**Re: Russell Street Development**

This firm represents the Market Wharf 1 Condominium Association (“MW”) and we write regarding the pending application of Port Harbor Land (“PHL”) for the so-called Russell Street Development. The lot proposed for development is the situs of a deeded parking easement owned by MW (“Easement”) for 58 vehicles, and we write with concerns about the intersection between MW’s parking rights and PHL’s proposals before this Board.

**Re: Site Review, Lot Line Revision & Conditional Use Permit Applications  
Proposed Mixed Use Development, Russell & Deer Street, Portsmouth, NH**

**North End  
Mixed Use  
Development**  
Two  
International  
Group  
Russell Street &  
Deer Street  
Portsmouth, NH

T-5037-002 POST  
Prepared by Tighe & Bond  
HydroCAD® 10.00-20 s/n 03436 © 2017 HydroCAD Software Solutions LLC  
Printed 9/22/2022  
Page 2

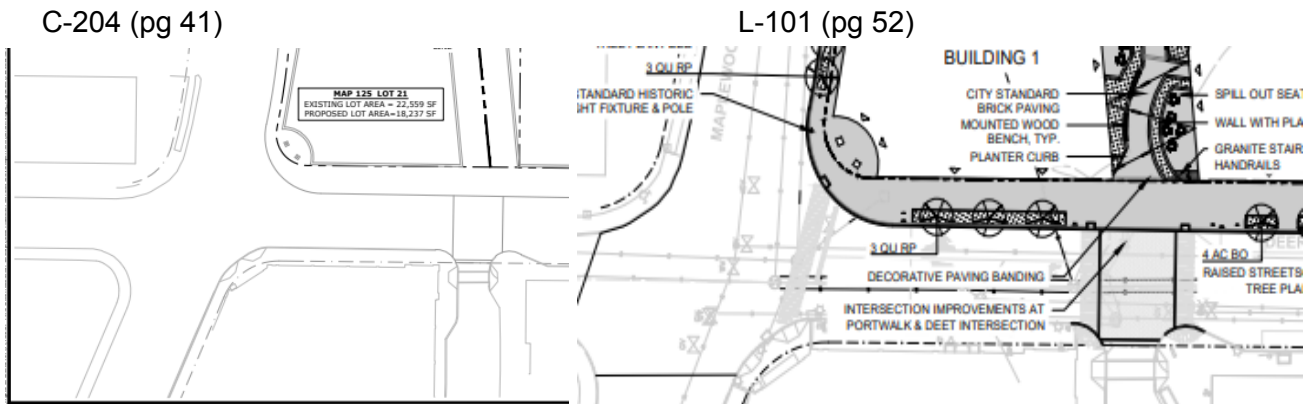
When comparing Pre and Post numbers the amount of “good” Pre is 29,047 sf (17.56%) vs the Post 15,941sf (9.64%). This is a decrease of “good” of 7.92% about 13,101 sf. A significant increase in impervious surface on the entire lot! It was made clear that detention basins were increased in size. Re-reviewing the drainage plans show Pre-PA-2 (pg 90) described as running off into a **gravel swale**. Based on the description of Post PA-2 there will no longer be a swale due to needing to provide a 20’ wide fire lane. *The concern is that the RR tracks are highly impervious and usually sit higher than the gravel on each side of them.* This causes whatever water that collects between the tracks to run off onto each side. It seems the Post results of PA-2 will be pooling along the RR track and the proposed fire road in the summer, even with the slight grade. The snow walls from plowing, will likely encourage ice forming on the fire road. A man made swale to direct and control the flow of this water, which is shown flowing toward Maplewood, could be considered, with grating along the length of the fire road to allow water from melting snow and all the “sheet flow” mentioned in both the pre and post descriptions to sheet flow under this driving/walking/riding area.
